PLANNING COMMISSION AGENDA

Planning Commission Staff Report May 23, 2024 Item C1

A RESOLUTION OF THE PLANNING COMMISSION OF THE CITY OF HOLLISTER DENYING SITE AND ARCHITECTURAL REVIEW 2022-6 TO CONSTRUCT A NEW 1,540 SQUARE-FOOT STARBUCKS BUILDING WITH 16 SETAS, A 1,065 SQUARE-FOOT OUTDOOT PATIO WITH 26 SEATS, A DRIVE-THROUGH AND ASSOCIATED INFRASTRUCTURE INCLUDING A PARKING LOT, AND LANDSCAPING LOCATED AT THE NORTHEAST CORNER OF INTERSECTION WESTSIDE BOULEVARD AND FOURTH STREET WITHIN THE NEIGHBORHOOD MIXED USE (NMU) ZONING DISTRICT (APN 052-040-020)

Figure 3 – Front (East) Elevation – on the eastern property side

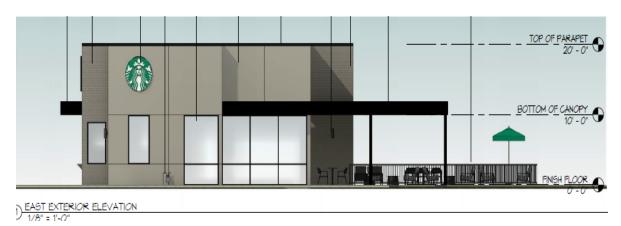
- 3. The project proposes a mural along the west and south building elevations that face Westside Boulevard and Fourth Street, respectively. However, enhanced architectural features and/or materials would provide for a more welcoming and pedestrian-oriented experience for those walking on the street and would invite pedestrian activity as is intended by the zoning designation. As designed, the pedestrian pathways direct pedestrians to walk across the drive-through and along these elevations to reach the rear

PROPOSED SITE PLAN

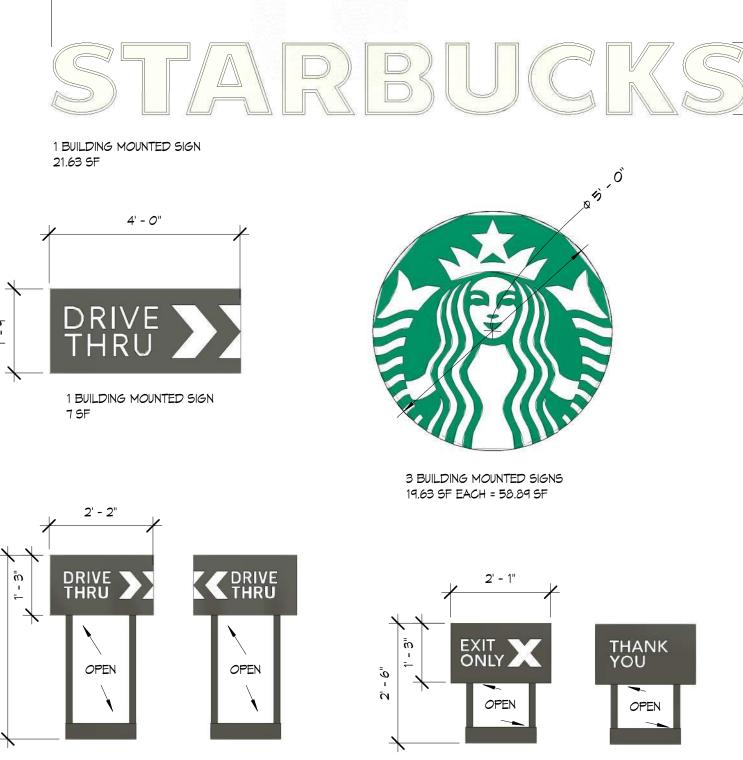
The proposed path does not provide pedestrian-friendly access along parking areas and along street frontages. To the contrary, the proposed path would require pedestrians to walk across landscaped areas and the drive-through lane to a path leading to the rear of the building where the single-door entrance is located. The path of travel should provide direct access from the sidewalk to the entrance. Additionally, the south and west elevations — which are oriented toward the two fronting streets — lack architectural enhancements that would invite pedestrians to walk toward and along the paths that extend from the sidewalks to the building entrance in the rear.

The placement of this building does not provide direct access to public sidewalks. It does not facilitate pedestrian access; pedestrians are required to walk from one corner of the parcel to access the pedestrian path which will lead them halfway through the parcel before directing them to the entrance of the building.
